Stop Use & Product Recall

3M™ PROTECTA® Cobra Rope Grab AC202D

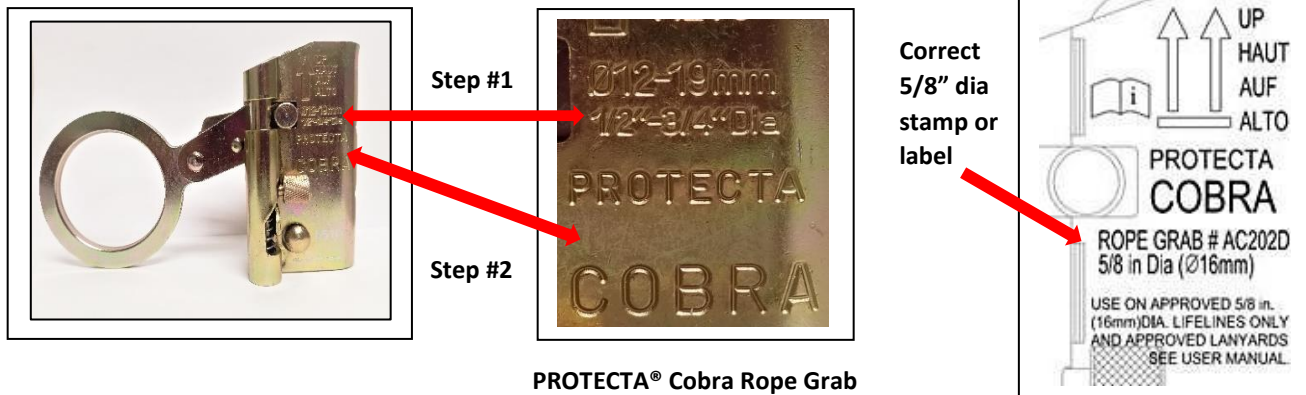
3M Fall Protection has determined that the 3M™ PROTECTA® Cobra Mobile/Manual Rope Grab AC202D is incorrectly stamped for use with 1/2 to 3/4 inch diameter rope on the exterior body of the unit. This Cobra Rope Grab is certified for use **ONLY** with 5/8 inch diameter polyester or polypropylene rope. All marketing information and the Instructions for Use (IFU) for this rope grab correctly identify the size of rope to be used as 5/8 inch polyester/polypropylene rope.

Step 1: Verify the rope diameter is stamped **1/2"—3/4" Dia** on the front side of the unit

Step 2: Verify the rope grab is stamped **PROTECTA COBRA** on the front side of the unit

Note: If the unit is stamped 5/8 inch diameter **OR** if the unit has a white label showing 5/8 inch diameter, then the unit is safe to return to normal use (see image on right for correct 5/8" diameter marking).

If the information in Step 1 and Step 2 is stamped onto the side of the rope grab as illustrated above, remove the unit from service immediately. Owners of AC202D Cobra Rope Grabs can choose one of the following options for each affected rope grab they own:

1. A free, new, properly marked replacement AC202D Cobra Rope Grab; or
2. A check for \$100.
